***SR9 WIDENING AND RECONSTRUCTION  
FROM SR 141 TO SR 20  
STP-1336(11), P.I. No. 121690  
Forsyth County, Georgia***

**Value Engineering Study Report  
Concept Submittal**

**re: SR 9 Widening from SR 141 to SR 20  
Project No. STP-1336(11), P.I. No. 121690  
Value Engineering Study Report**

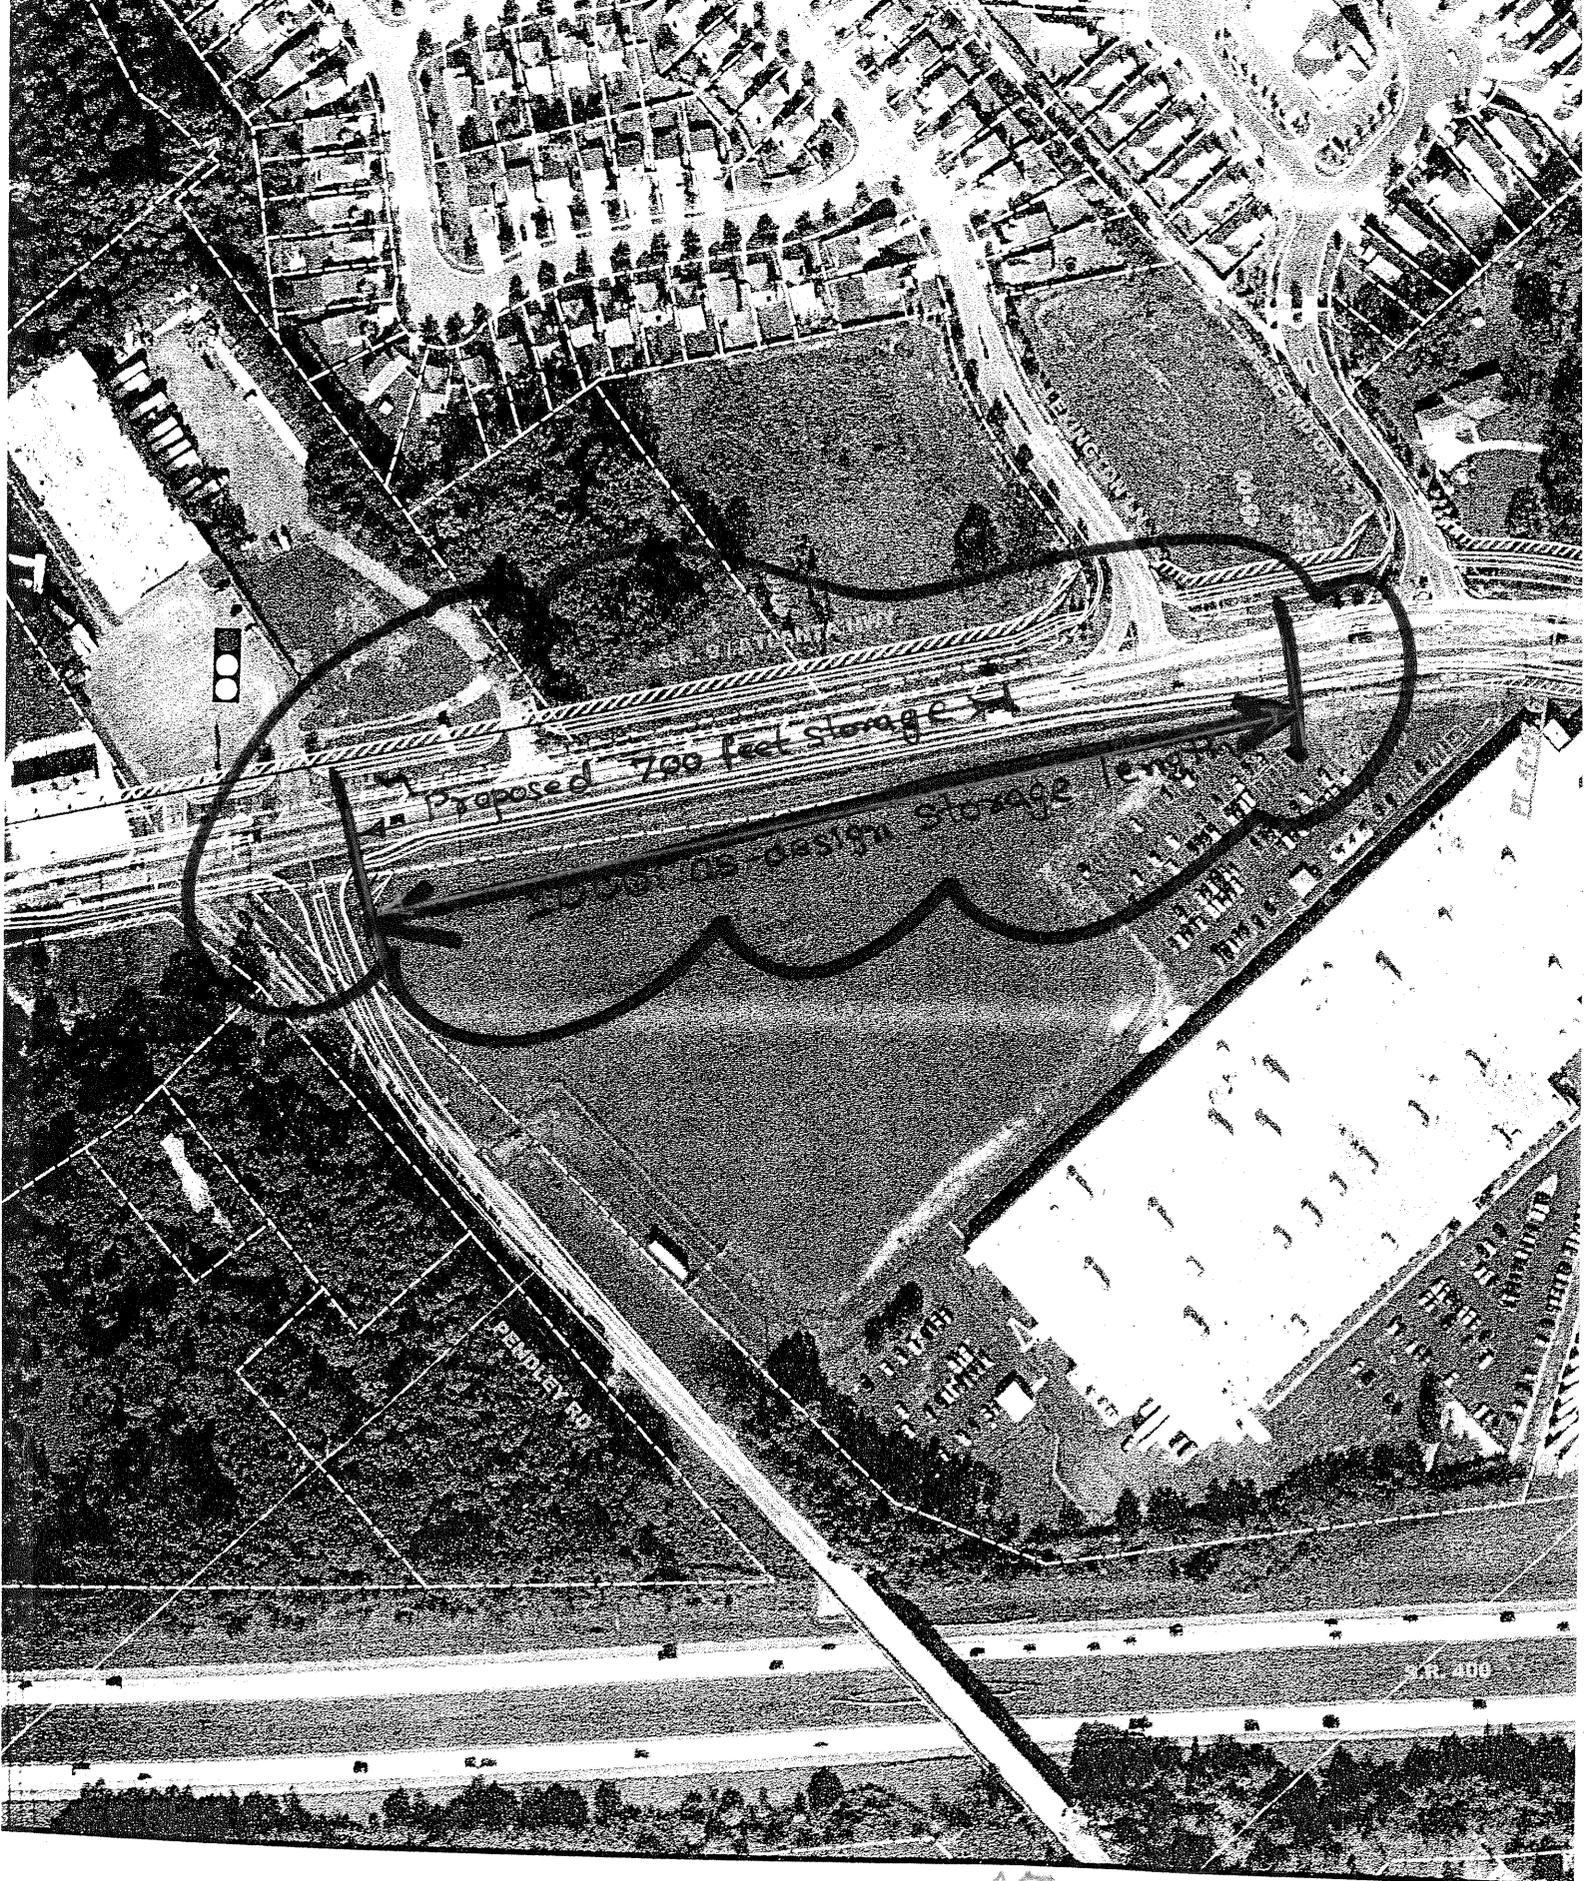
Instead of 1,000 ft. of storage length, provide 700 ft. of storage length (enough for 35 vehicles on average). This will save 300 ft. of 12-ft. wide asphalt pavement.

- On some days, traffic may back-up on SR 9 and occupy one of its lanes

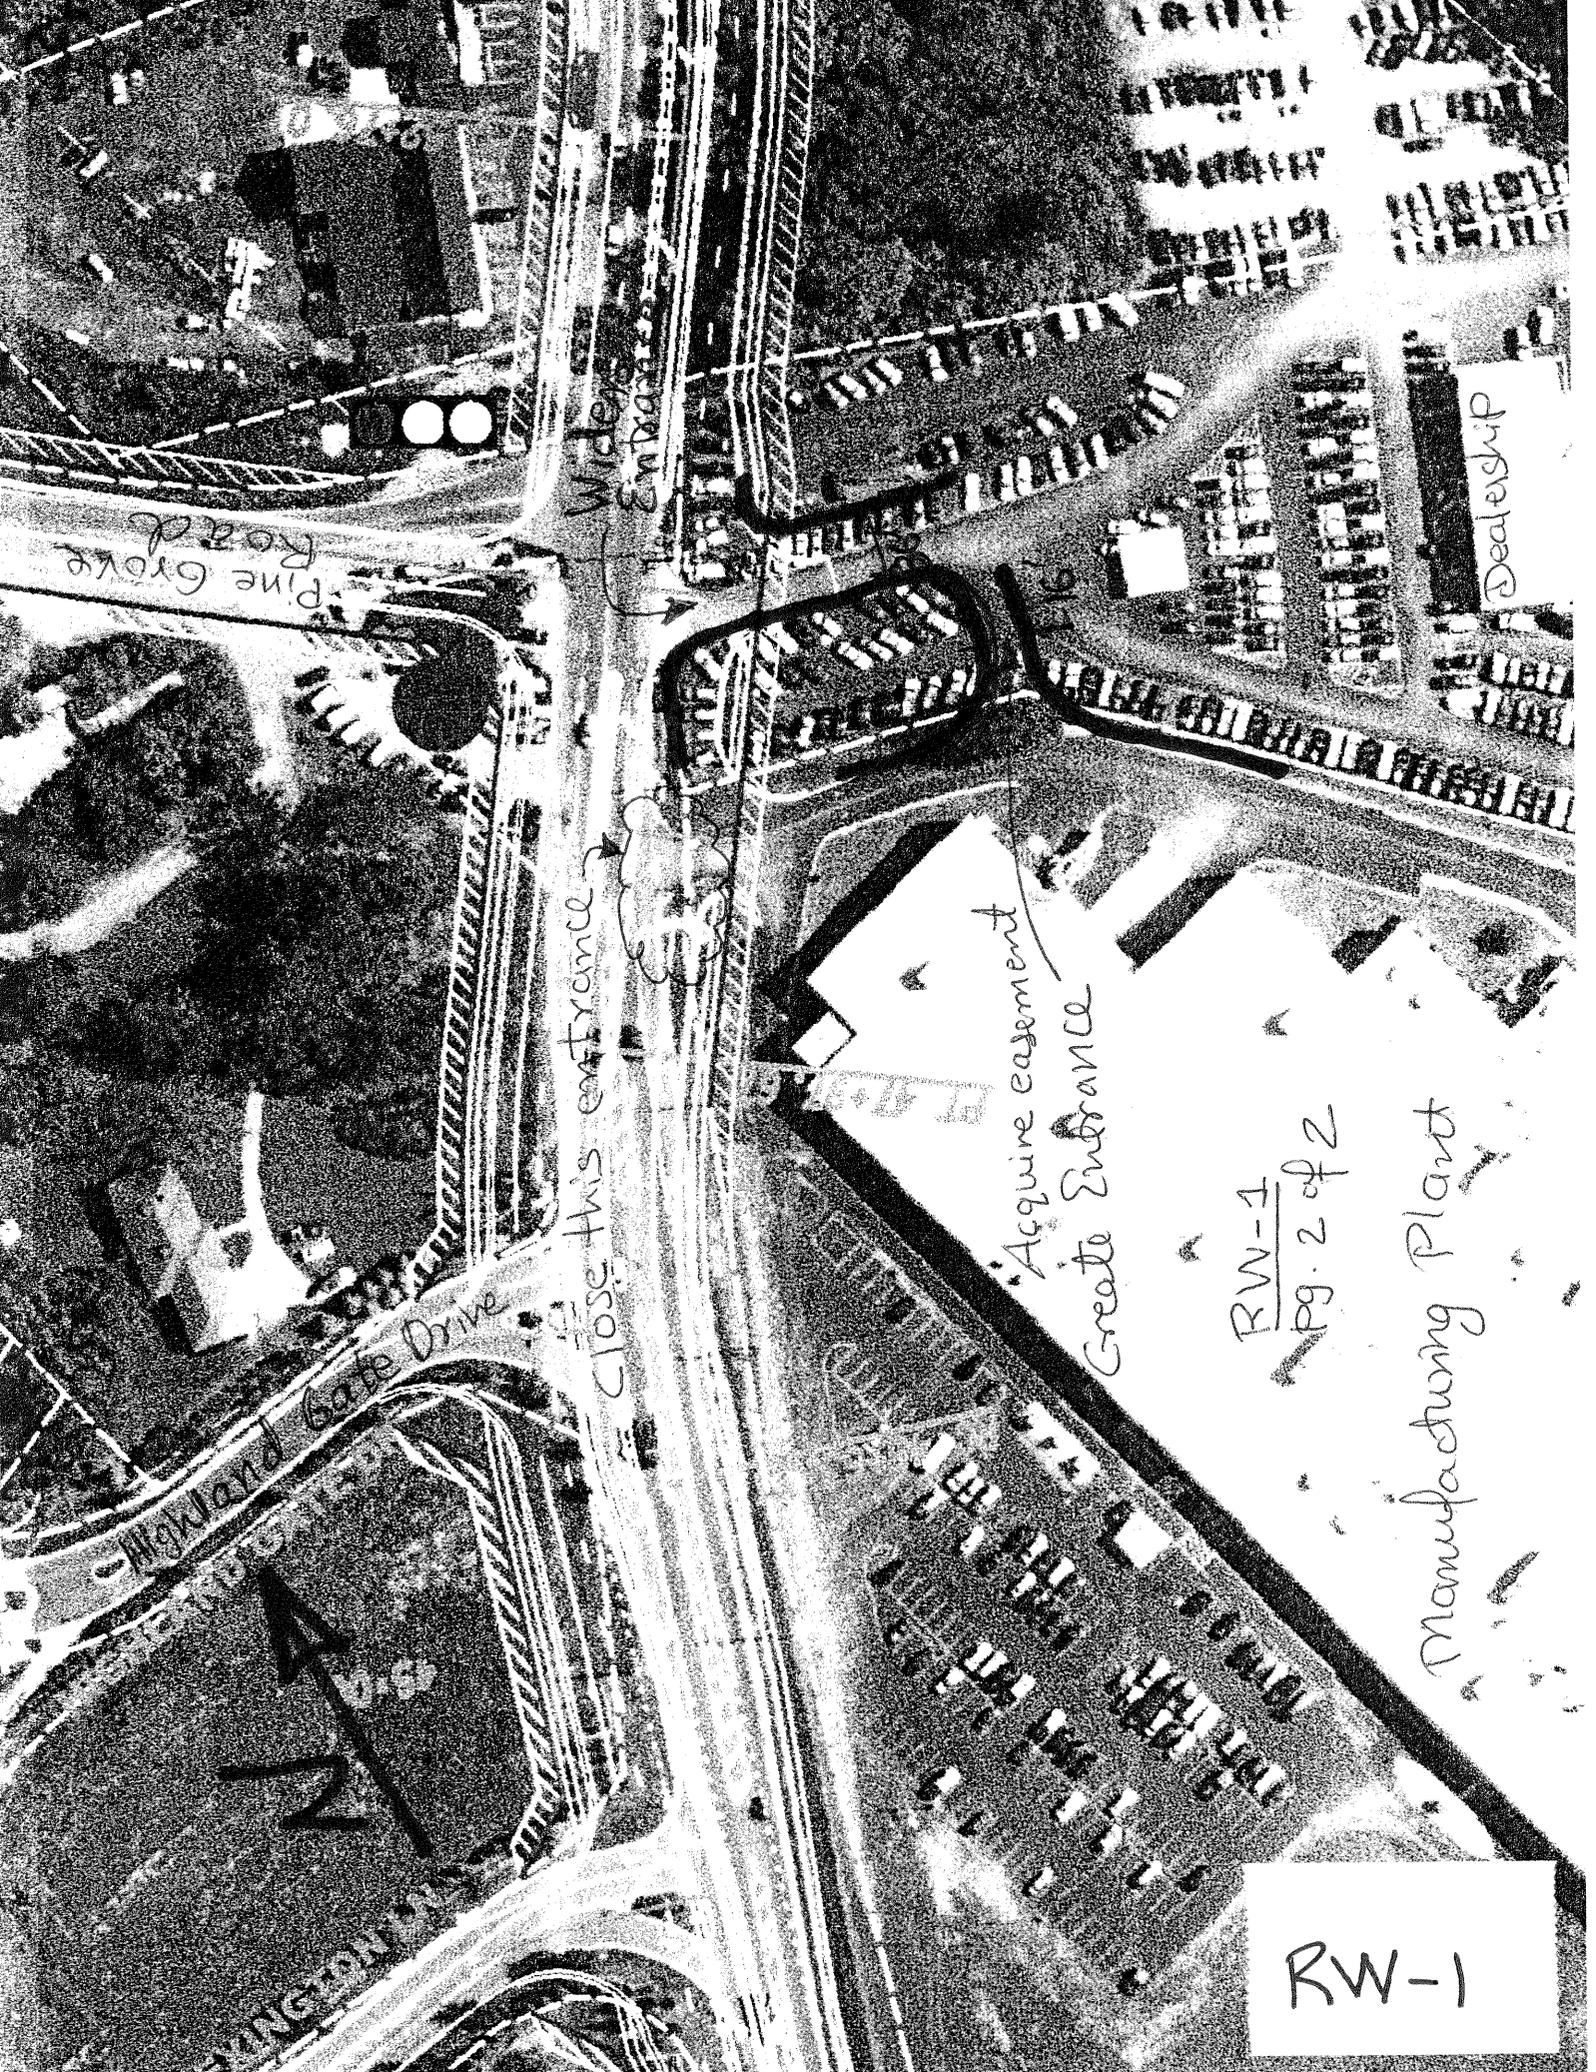
The center-to-center distance between the manufacturing plant driveway and the dealership driveway is only 125 ft. This poses a traffic hazard because these driveways are at the street intersection.

Close the manufacturing plant driveway. Widen the dealership driveway to a 36-ft. width with one 12-ft. left turn lane. Acquire permanent easement from the dealership owner so that the plant employees and others have the rightful access.

RW-4

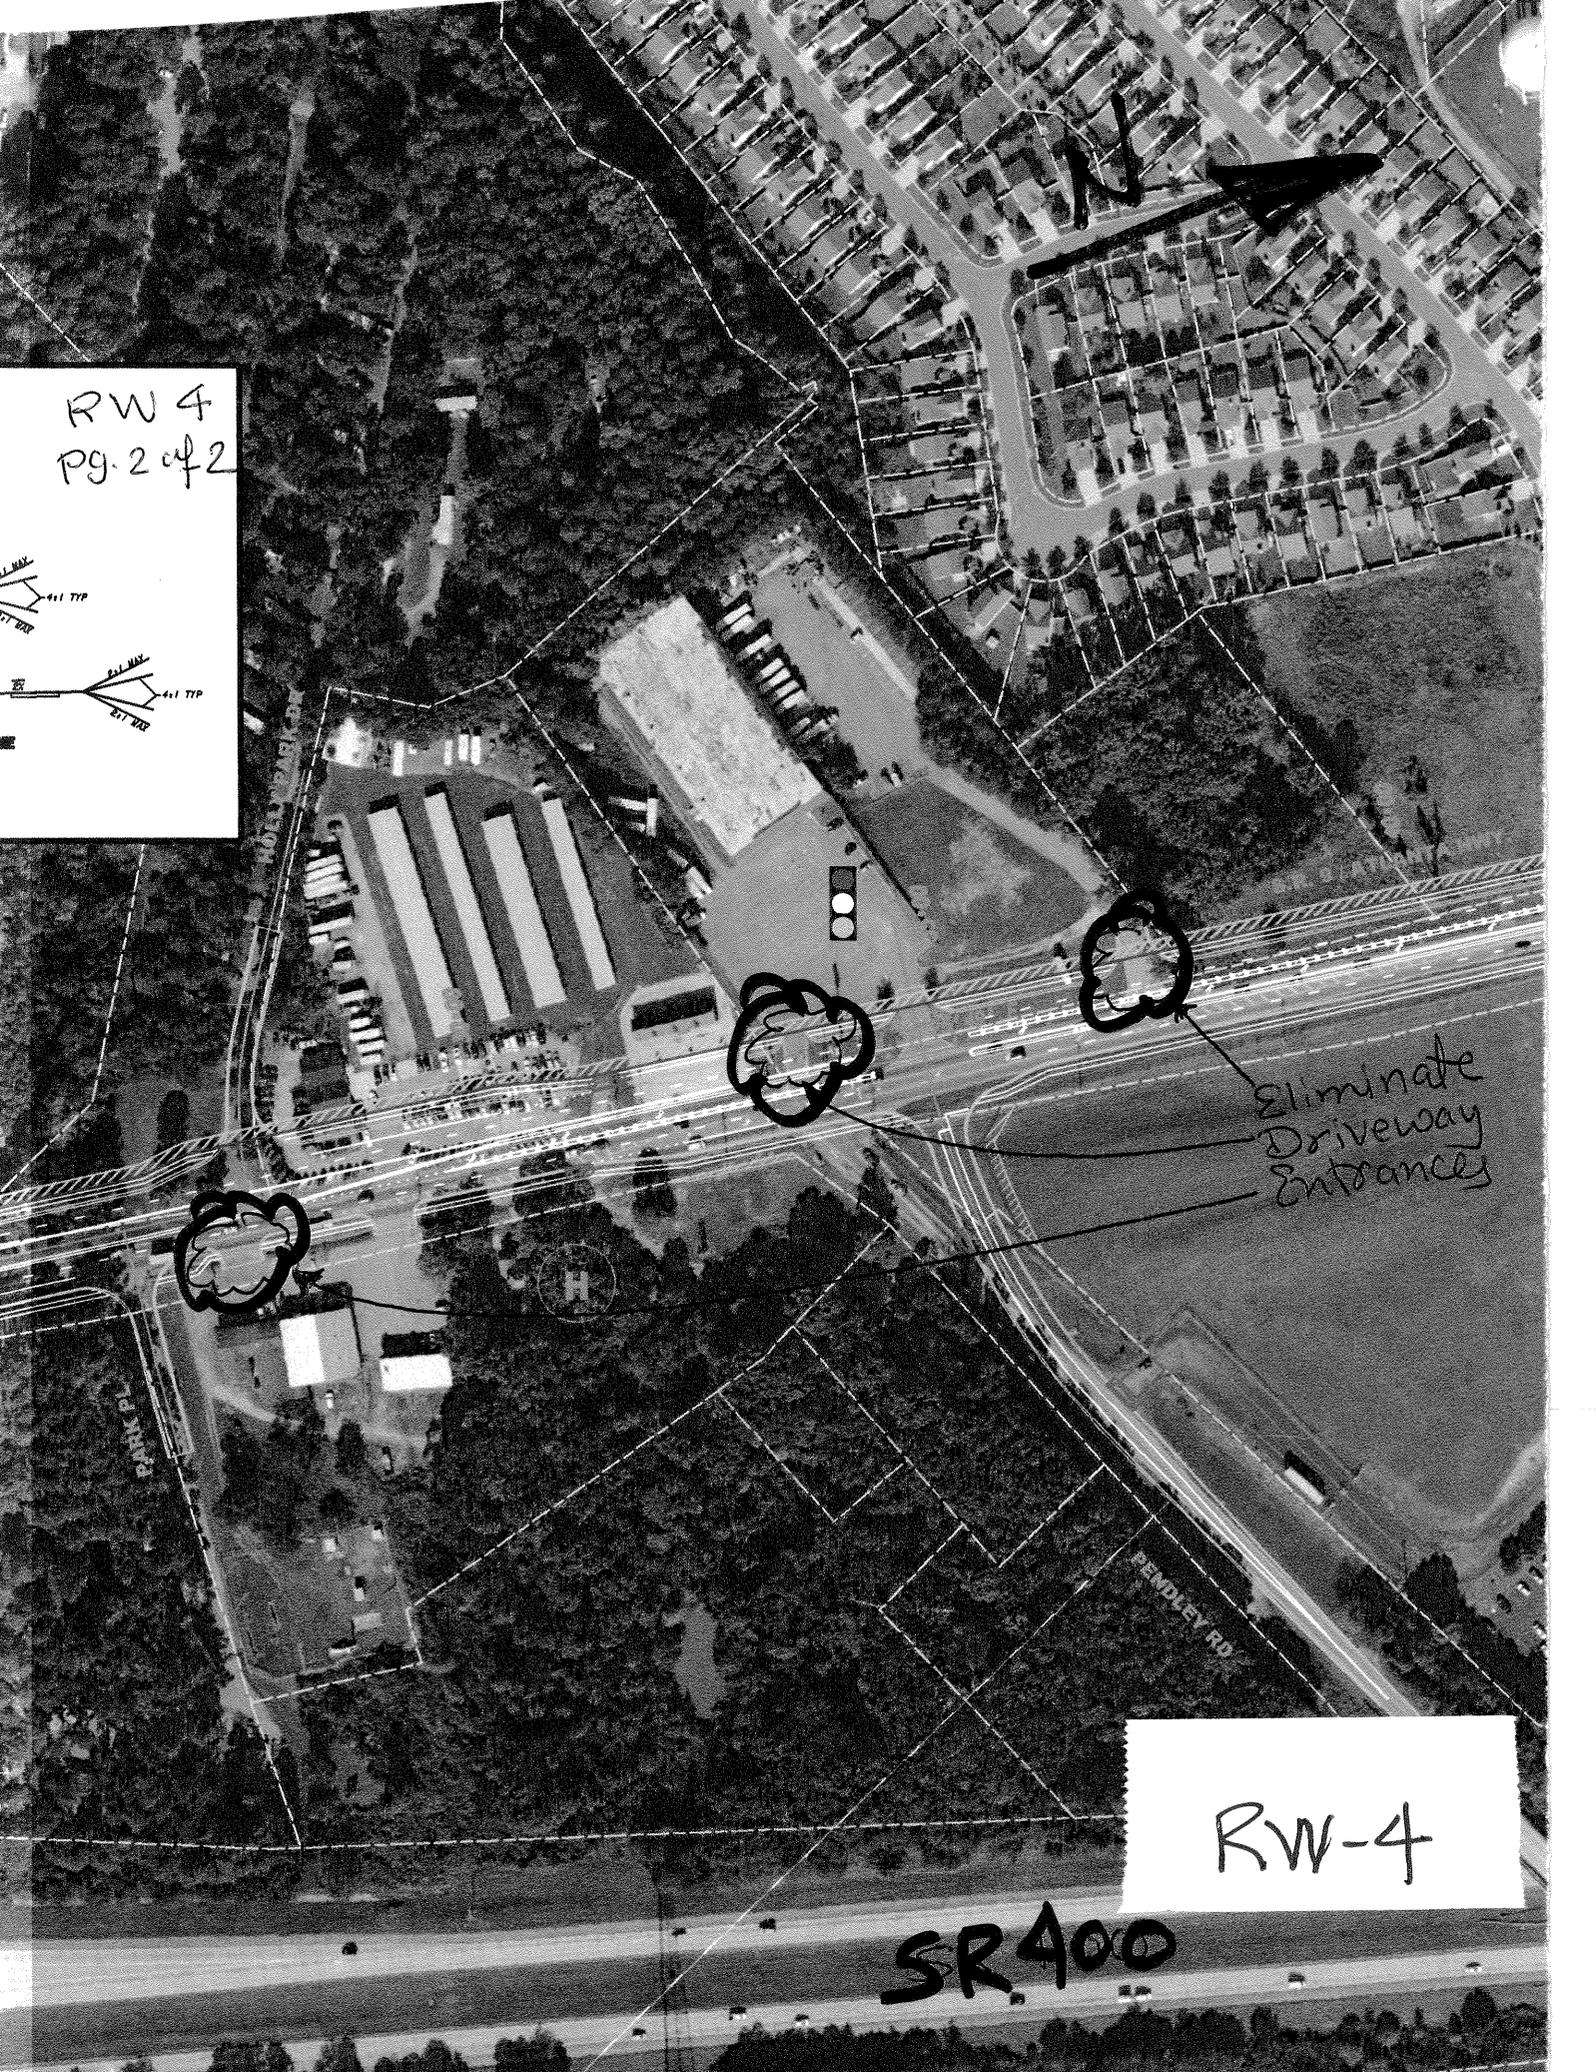
Eliminate  
Driveway  
Entrances
